## T10/04-378r2 SAS-1.1 Clarification of SATA Signaling Level Specification

To: T10 Technical Committee  
From: Barry Olawsky, HP (barry.olawsky@hp.com)  
Date: 10 February 2005  
Subject: T10/04-378r2 SAS-1.1 Clarification of SATA Signaling Level Specification

Evaluate validity of SATA mode receiver sensitivity spec for XR and IR.

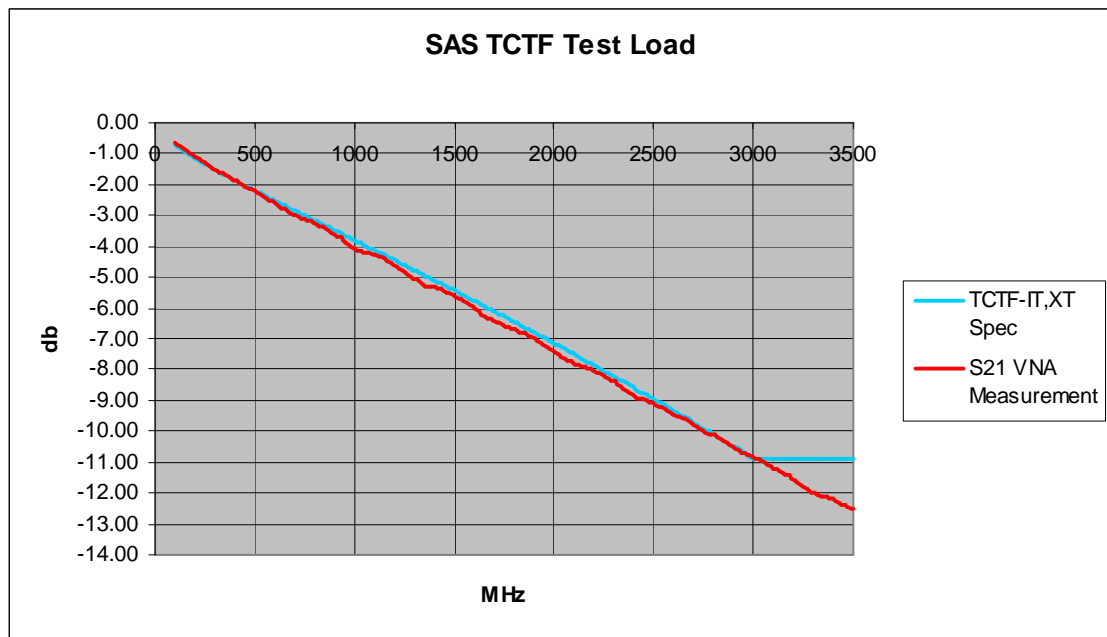
Add following note to table 30 referencing the 225mV cell in SATA column.

~~Amplitude measurement methodologies of Serial ATA and this standard differ. Under conditions of maximum rise/fall time and jitter, eye diagram methodologies may indicate far less amplitude than the technique specified by the Serial ATA standard. To compensate for this difference, it is recommended that Serial ATA devices used in SAS applications undergo additional testing. Eye diagram tests should be used to confirm the minimum SATA device amplitude specified in the Serial ATA specification. SAS implementers using SATA drives are required to ensure interoperability. Additional system characterization with an eye diagram methodology should be performed.~~
